ALTERNATIVE METHODS OR CONSTRUCTION MATERIALS REQUEST

E21-0571

2ND STREET APARTMENTS
 SITE PLAN

1 SITE PLAN
 1" = 20'
 NOTE: SITE PLAN NOT FROM SURVEY

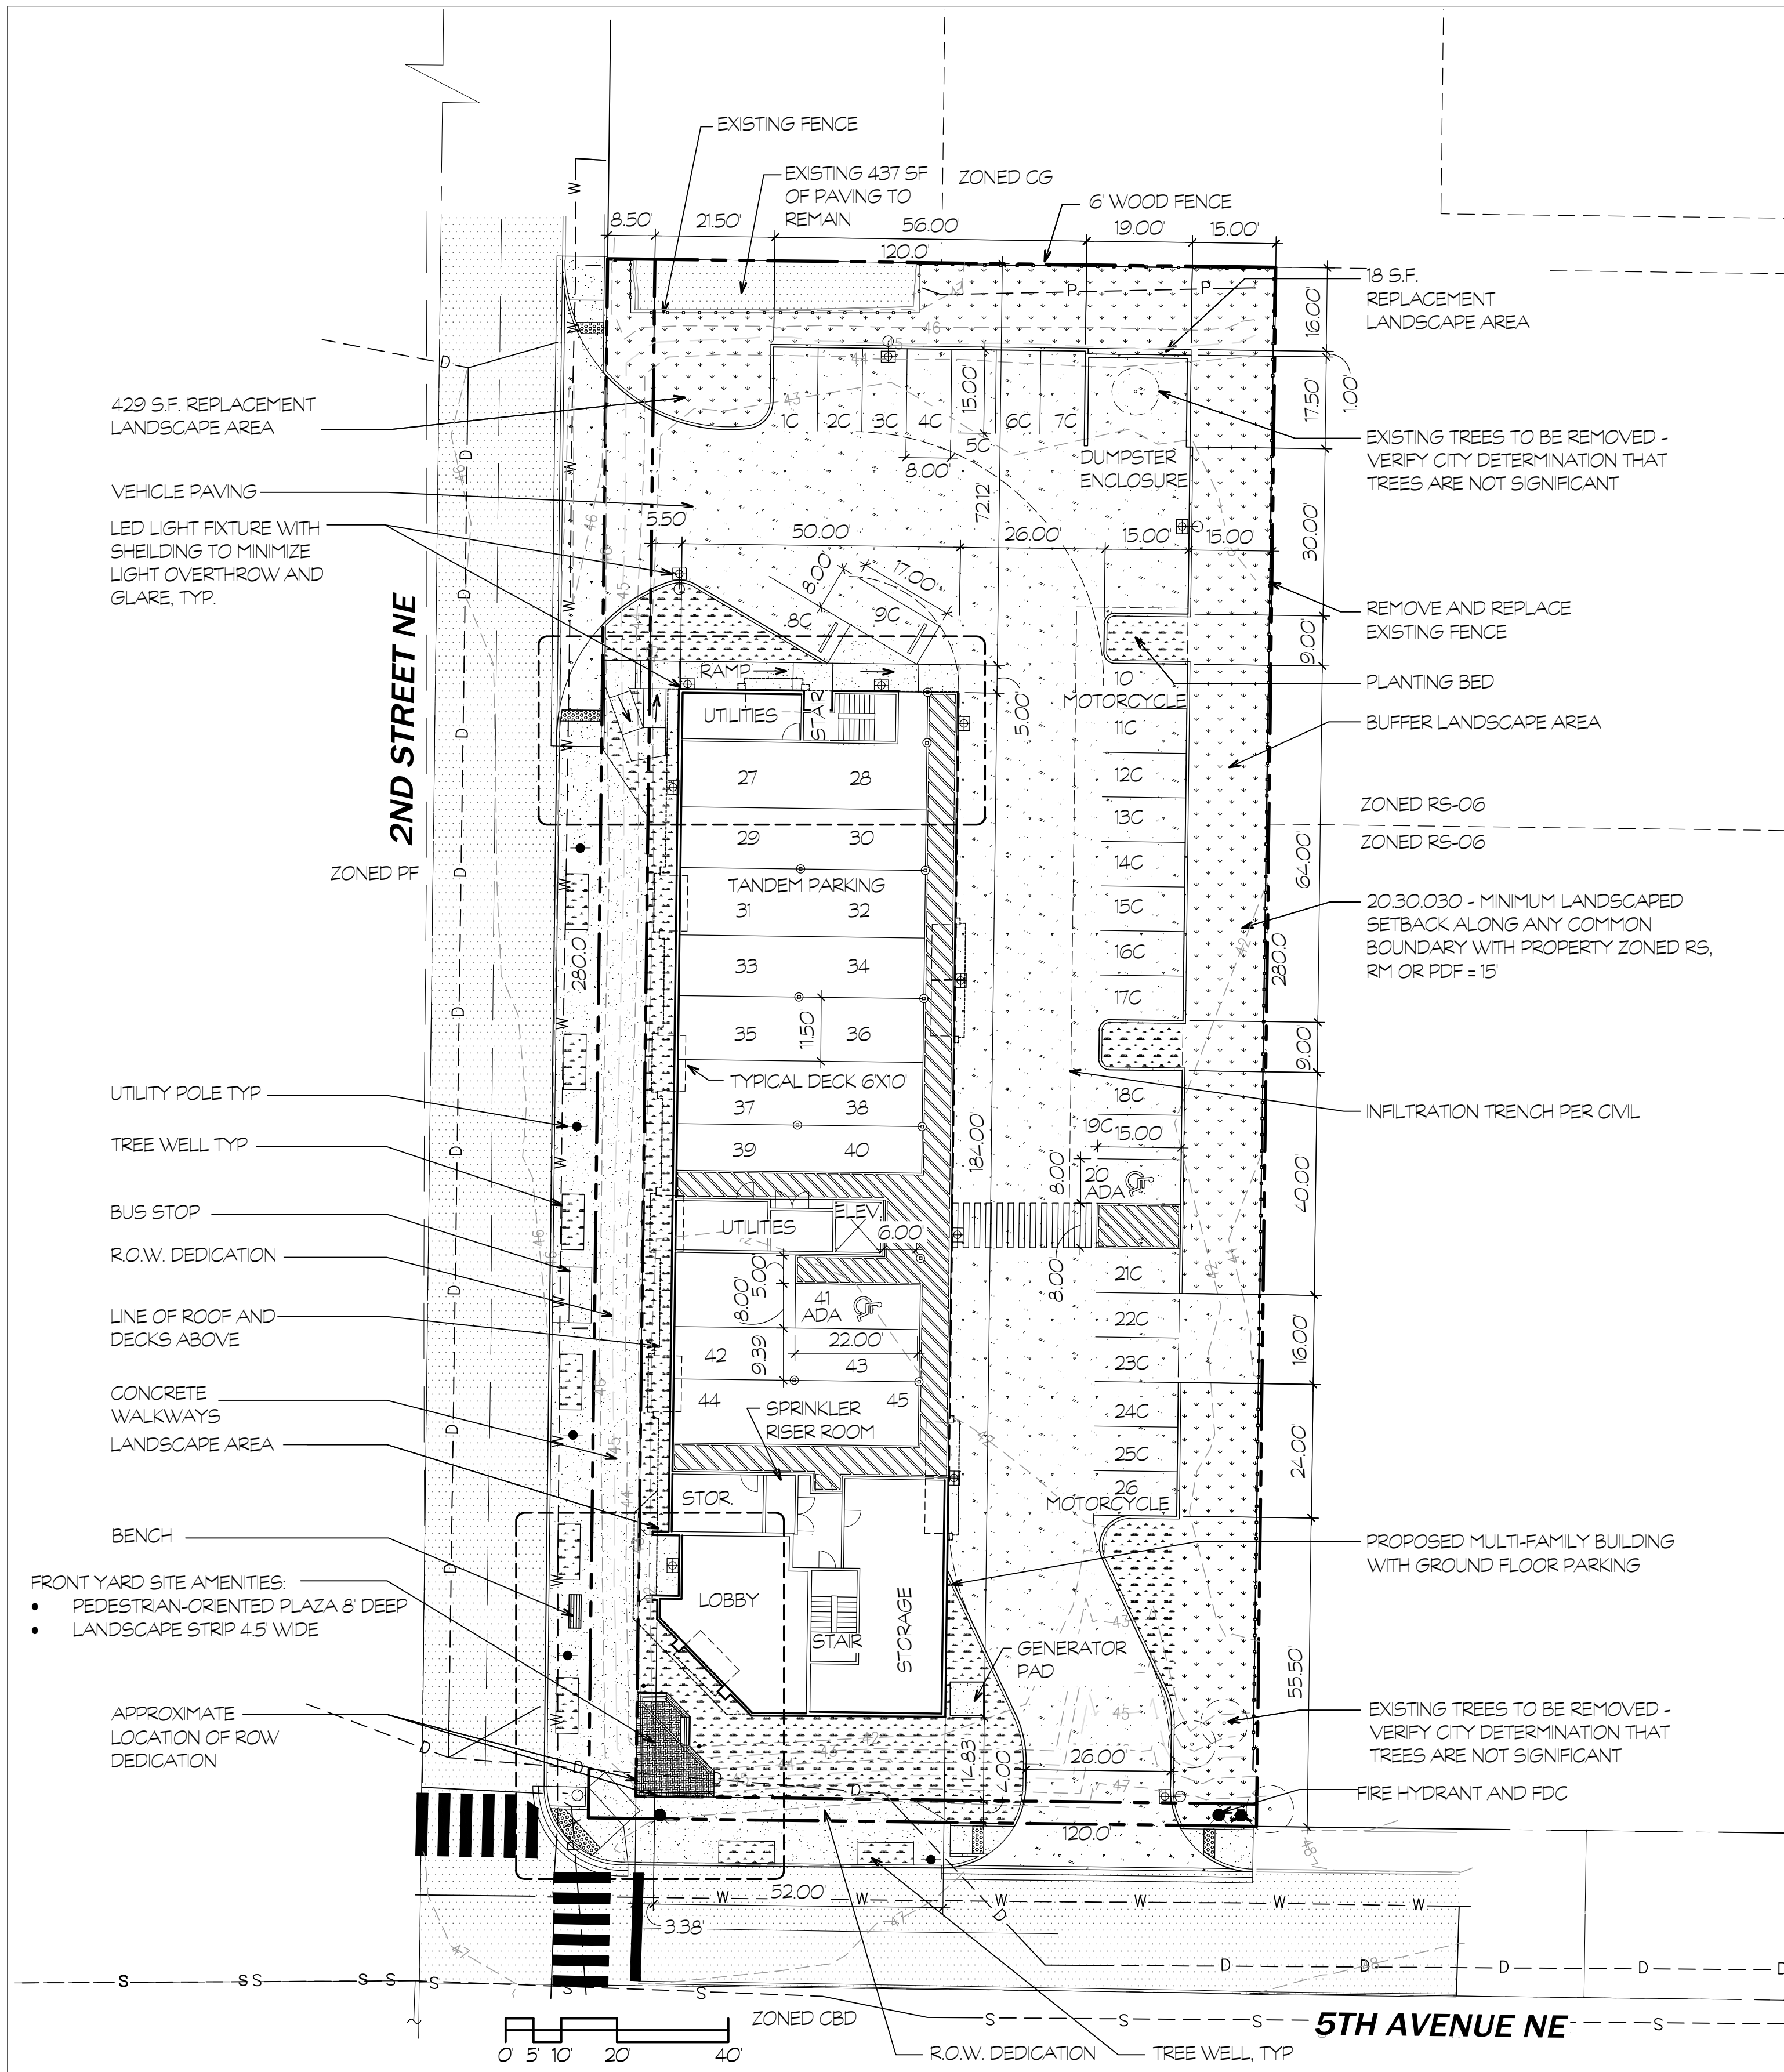
Section 101.10.1 of the Puyallup Public Works Engineering & Construction Standards restricts driveway spacing on collectors to no closer than 150 feet to an intersection.
The project proposes to locate the driveway to 5th Ave NE, a Major Collector, at reduced spacing. The proposed driveway would be spaced approximately 100 feet from the intersection of 2nd St NE and 5th Ave NE.

A yellow painted "C"-curb will be installed along the centerline of 5th Ave NE in front of the proposed driveway. This will prevent left turn entry and exit maneuvers which could potentially cause backup into the intersection.
The driveway approach will be designed to current county standards. A reduction to the standard intersection spacing is appropriate with restriction of the driveway to right-in/right-out only and is based on sound engineering judgment. The restricted right-in/right-out movement should have no impact to east- or west-bound traffic on 5th Ave NE.

STAFF RECOMMENDATIONS	APPROVED	DENIED	DATE
Development Engineering			1/24/2022
Conditions: At time of civil application, provide auto-turn for largest vehicle accessing the entrance to ensure no mounting of curbs and sidewalk.			
Planning Department	N/A		
Conditions:			
Traffic Engineering	X		1/21/2022
Conditions: Driveway must provide pavement markings & signage indicating right-in/right-out operation at 5th Avenue NE. C-curb will be required to prevent inbound left turns. City standard c-curb end treatments will be required.			
Public Works - Streets	per SHill email dated 11/23/21		11/23/2021
Conditions: No objections.			
Public Works - Water	per CHale email dated 11/16/21		11/16/2021
Conditions: The Water Division has no comments on this AMR, we defer to the City Engineer			
Public Works - Collections	per JWikander email dated 11/16/21		11/16/2021
Conditions: If approved, please make sure all storm and/or sewer structures will be updated as needed should they conflict with the new entrance(s). Otherwise, no comments.

APPROVED	DENIED	DATE
City Engineer			1/24/2022
